PCN – Product Change Notification

PCN-A-120403

PCN Topic: Mechanical change of Winmate W22L100-PMA1

Old Mechanical Dimension (21.5" A1):

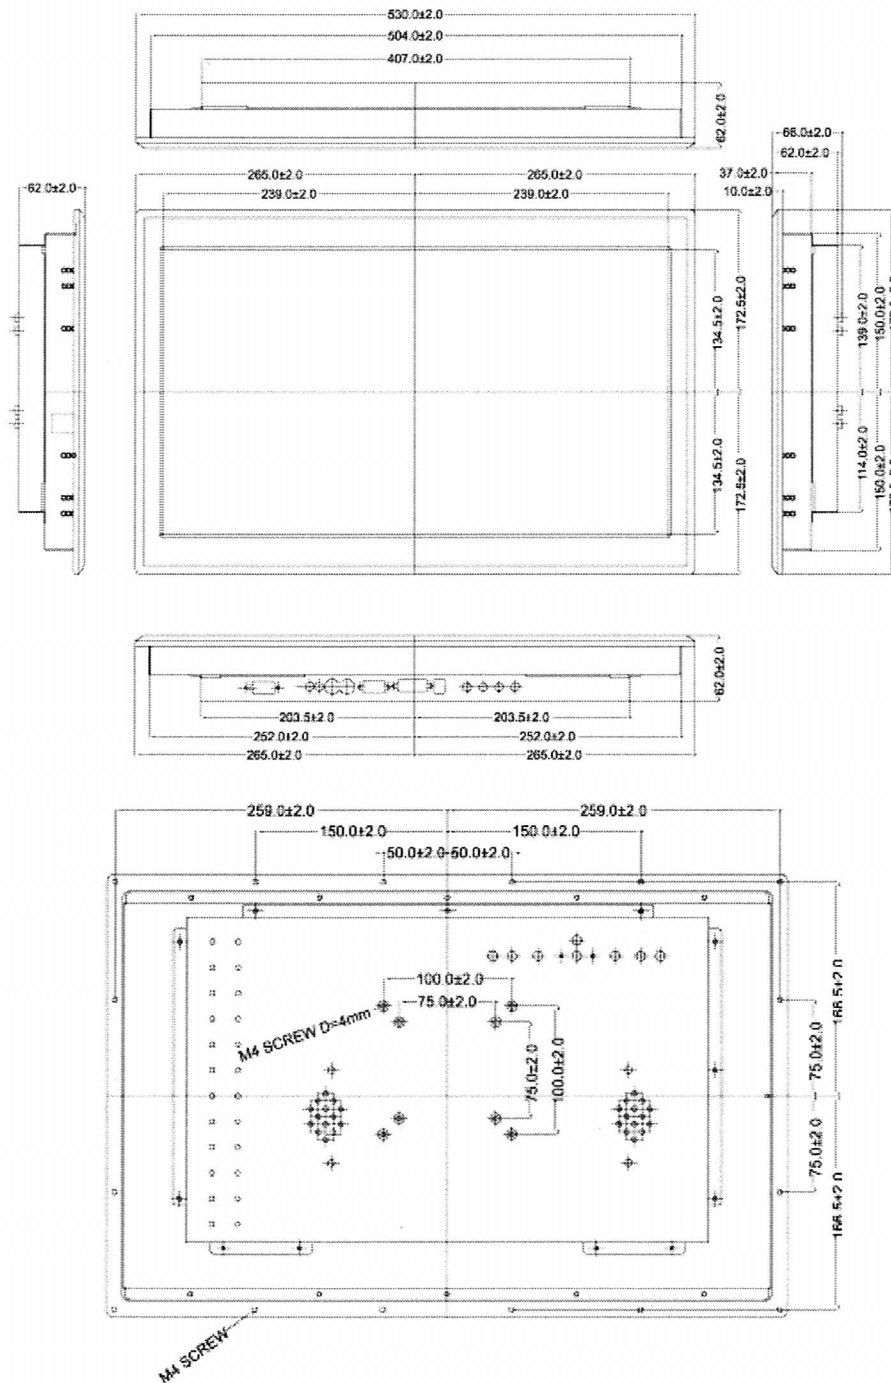
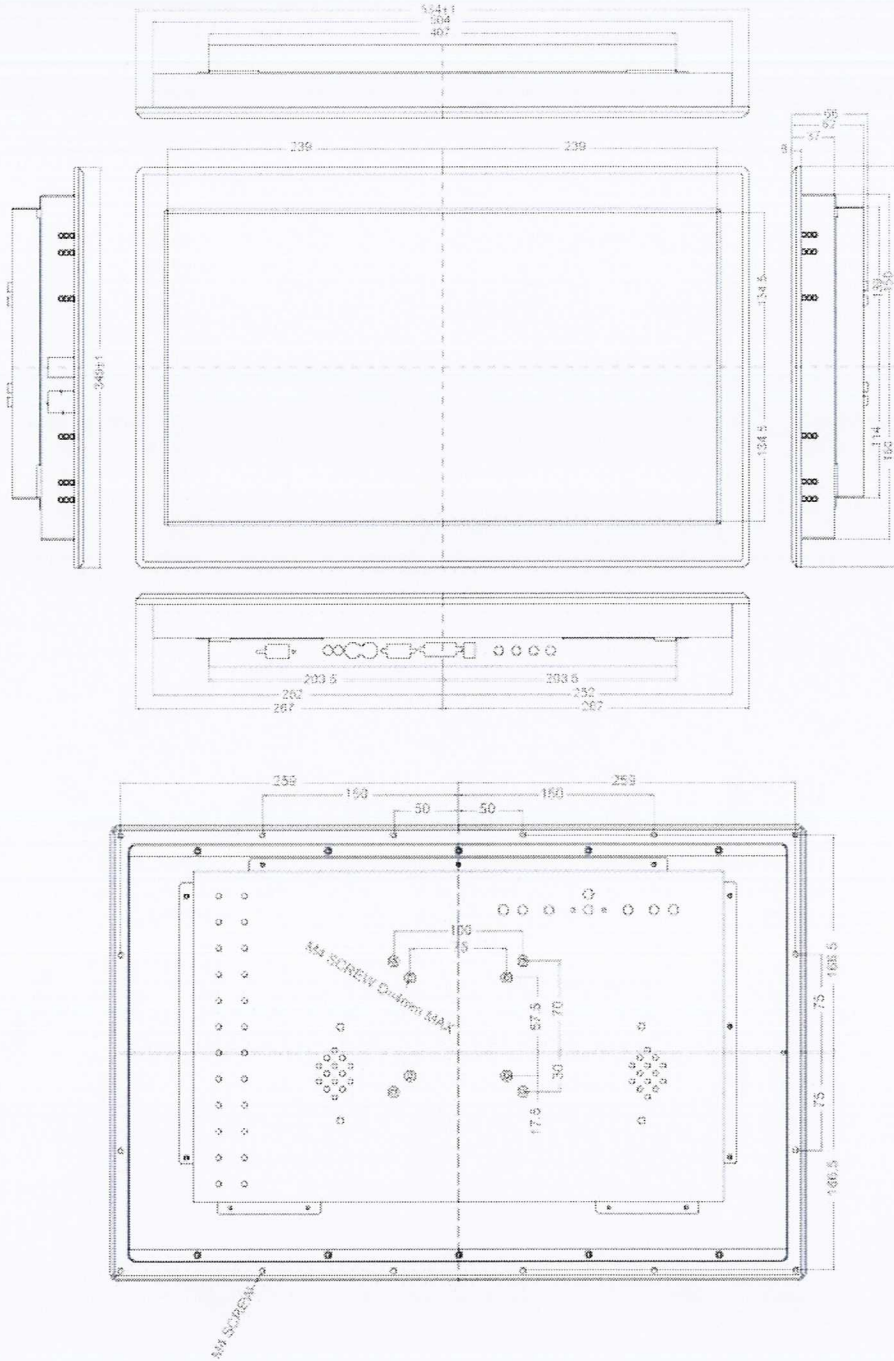
The dimension of Panel Mount mechanical will change from 530 x 345 x 62 mm to 534 X 349 X 62.0 mm. Panel Mount front bezel from 10mm to 8mm.
